A12 Chelmsford to A120 widening scheme

8.12 Statement of Common Ground with Essex County Council

A12 Chelmsford to A120 widening scheme
Development Consent Order 202[]

Statement of Common Ground with Essex County Council

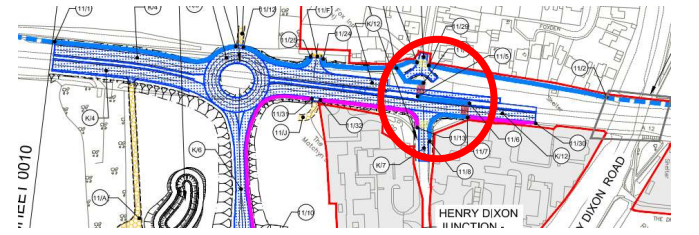
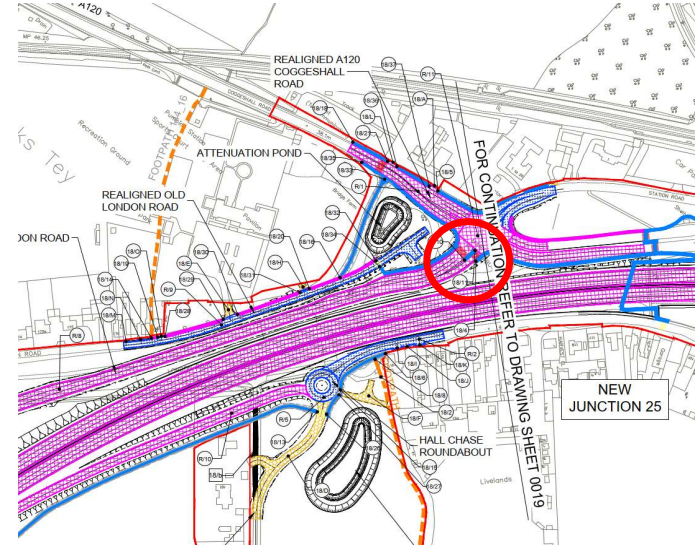
Adjacent to southbound carriageway	Ramp direction More constrained by adjacent ground levels	Minimal-	No change in ramps overall alignment. Investigate scope for minimum 5m radii on all bends (detailed design)	Bridge ramp should be redesigned to provide a more direct route for users, with fewer zig-zag foldbacks, if possible, and 5m radius (minimum) turns where ramp sections change direction – in accordance with LTN 1/20. Evidence has not been provided to prove that all alternative ramp layouts have been exhausted. Further design investigation could reveal suitable alternatives to current design. 'Investigate scope for minimum 5m radii on all bends' falls short of actually providing 5m radii on all bends. This should be committed to and design amended The ramps and the bridge itself should be designed in accordance with best practice for pedestrians, cyclists and ridden horses

NH Cycling Matrix with ECC Comments - 'Surface Crossings'

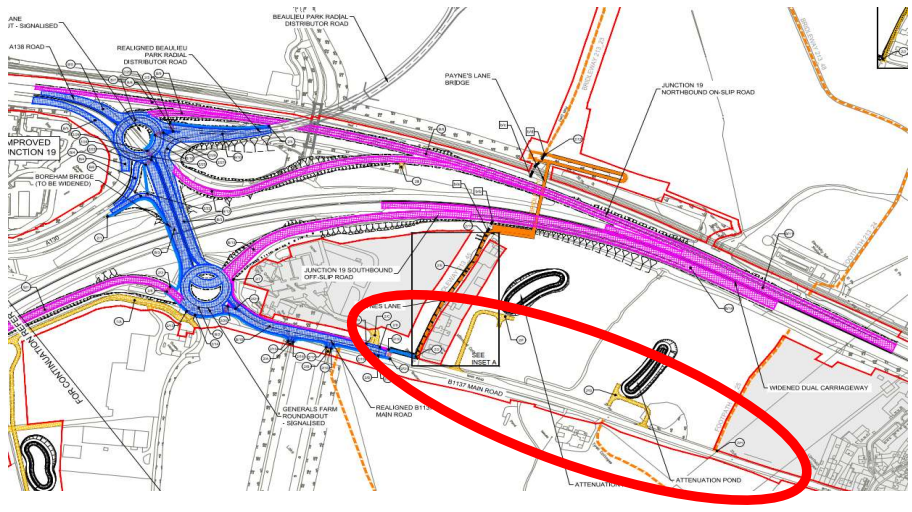
Name/route	Image	User groups	Designed for	A12 Chainage (approx.) and General Arrangement Sheet Number	Geometric constraints/scope	Traffic aspects	Conclusions: Green: Amend Amber: Continue discussions with ECC technical officers	ECC Comments DRAFT																																																																																																
Eastways/Colchester Road		Pedestrians, Cyclists	Pedestrians, Cyclists,	22,900 Sheet 10 of 21	None	None. Movement removed from Eastways/Colchester road/Trade Park junction but remains on desire-line	Straighten crossing in detailed design stage	Traffic modelling needs to be provided to demonstrate that the impact of straight across cycle crossings would be acceptable (with separate staggered pedestrian facilities, if required).																																																																																																
Henry Dixon Road/Braxted Road		Pedestrians, Cyclists	Pedestrians, Cyclists,	24100, Sheet 11 of 21	None	<p>Degree of Saturation over 85-90% shows some congestion.</p> <p>Staggered</p> <table border="1" data-bbox="1656 953 2012 1184"> <thead> <tr> <th rowspan="2">Arm</th> <th colspan="3">AM</th> <th colspan="3">PM</th> </tr> <tr> <th>DoS (%)</th> <th>MMQ (PCU)</th> <th>Avg PCU delay (sec)</th> <th>DoS (%)</th> <th>MMQ (PCU)</th> <th>Avg PCU delay (sec)</th> </tr> </thead> <tbody> <tr> <td>Old A12</td> <td>76.3%</td> <td>13</td> <td>26.4</td> <td>70.0%</td> <td>12.8</td> <td>16</td> </tr> <tr> <td>Henry Dixon Road</td> <td>74.50%</td> <td>9.6</td> <td>28.1</td> <td>75.00%</td> <td>7.1</td> <td>38</td> </tr> <tr> <td>Braxted Road</td> <td>62.80%</td> <td>5.5</td> <td>25.7</td> <td>76.60%</td> <td>3.8</td> <td>31.1</td> </tr> <tr> <td>Practical Reserve Capacity (PRC)</td> <td colspan="3">18.0%</td> <td colspan="3">17.50%</td> </tr> <tr> <td>Cycle Time</td> <td colspan="3">77</td> <td colspan="3">77</td> </tr> </tbody> </table> <p>Single-stage</p> <table border="1" data-bbox="1656 1213 2012 1444"> <thead> <tr> <th rowspan="2">Arm</th> <th colspan="3">AM</th> <th colspan="3">PM</th> </tr> <tr> <th>DoS (%)</th> <th>MMQ (PCU)</th> <th>Avg PCU delay (sec)</th> <th>DoS (%)</th> <th>MMQ (PCU)</th> <th>Avg PCU delay (sec)</th> </tr> </thead> <tbody> <tr> <td>Old A12</td> <td>88.5%</td> <td>23.4</td> <td>53.9</td> <td>89.6%</td> <td>28</td> <td>47.3</td> </tr> <tr> <td>Henry Dixon Road</td> <td>89.70%</td> <td>20.3</td> <td>60.2</td> <td>92.80%</td> <td>15.9</td> <td>82.8</td> </tr> <tr> <td>Braxted Road</td> <td>89.30%</td> <td>10.7</td> <td>53.7</td> <td>94.90%</td> <td>13.8</td> <td>81.5</td> </tr> <tr> <td>Practical Reserve Capacity (PRC)</td> <td colspan="3">0.3%</td> <td colspan="3">-5.50%</td> </tr> <tr> <td>Cycle Time</td> <td colspan="3">120</td> <td colspan="3">120</td> </tr> </tbody> </table> <p>Junction works with forecasted traffic, but not as well. Is this drop in performance acceptable?</p>	Arm	AM			PM			DoS (%)	MMQ (PCU)	Avg PCU delay (sec)	DoS (%)	MMQ (PCU)	Avg PCU delay (sec)	Old A12	76.3%	13	26.4	70.0%	12.8	16	Henry Dixon Road	74.50%	9.6	28.1	75.00%	7.1	38	Braxted Road	62.80%	5.5	25.7	76.60%	3.8	31.1	Practical Reserve Capacity (PRC)	18.0%			17.50%			Cycle Time	77			77			Arm	AM			PM			DoS (%)	MMQ (PCU)	Avg PCU delay (sec)	DoS (%)	MMQ (PCU)	Avg PCU delay (sec)	Old A12	88.5%	23.4	53.9	89.6%	28	47.3	Henry Dixon Road	89.70%	20.3	60.2	92.80%	15.9	82.8	Braxted Road	89.30%	10.7	53.7	94.90%	13.8	81.5	Practical Reserve Capacity (PRC)	0.3%			-5.50%			Cycle Time	120			120			Junction works with forecasted traffic, but not as well. Is this drop in performance acceptable?	No, the drop in performance is not acceptable. The junction should be amended to include a straight across cycle crossing with separate staggered pedestrian facilities. This layout should then be reassessed and the results of the traffic modelling provided.

Hatfield Peverel Rail Station to Witham

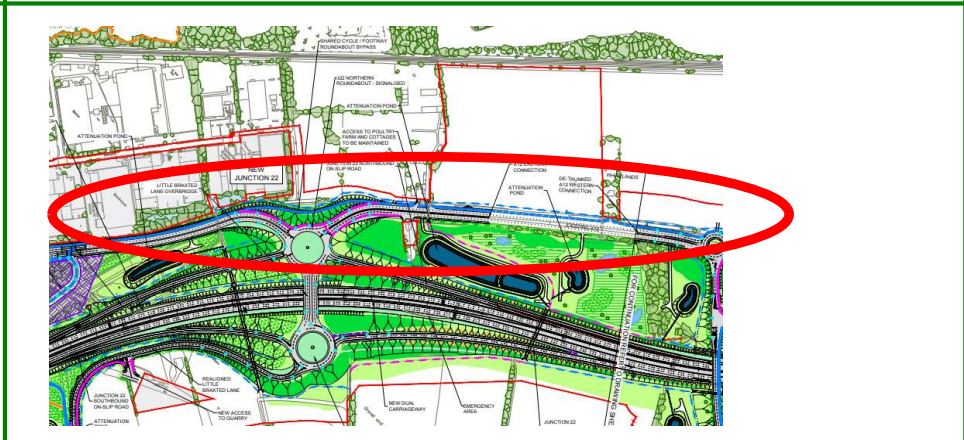
A new walking and cycling route should be included (within the proposed red line boundary) to north of Junction 21, to connect new developments in Witham to Hatfield Peverel station

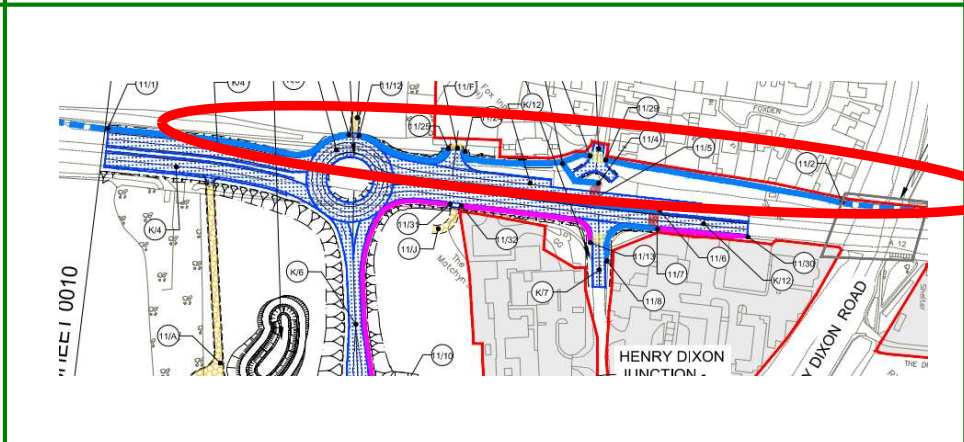
A link through this land would provide the residents of the new development with a safe and car free route to the train station, encouraging sustainable travel and avoiding the busy main road and junctions through Hatfield Peverel.

Junction 22 to Rivenhall

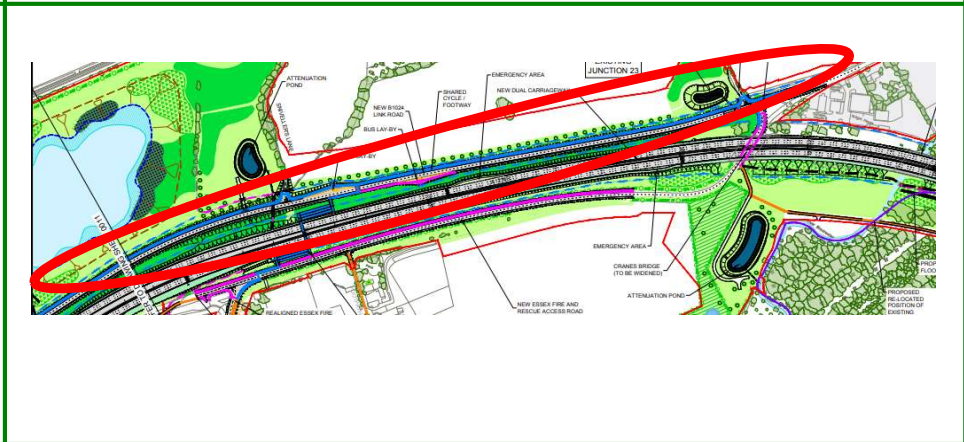
Upgraded walking and cycling facilities should be provided along whole length of de-trunked section to a minimum of 3m wide shared use 2-way cycle/footway.

Rivenhall

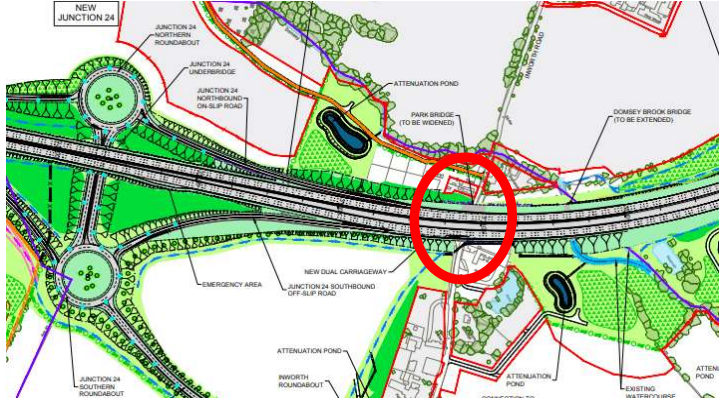
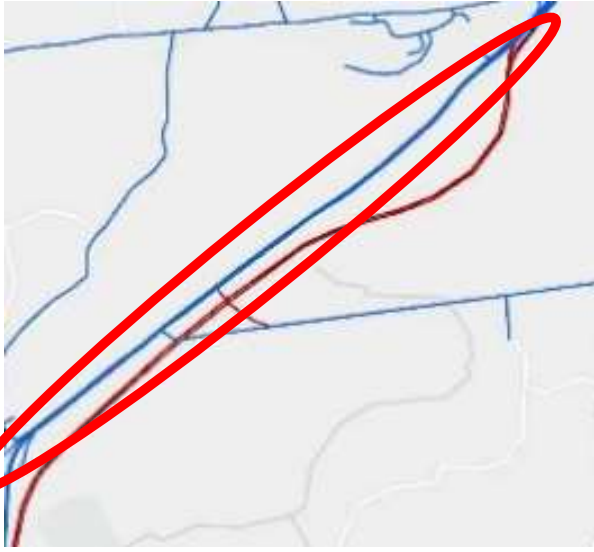
Upgraded walking and cycling facilities should be provided along whole length of de-trunked section to a minimum of 3m wide shared use 2-way cycle/footway.
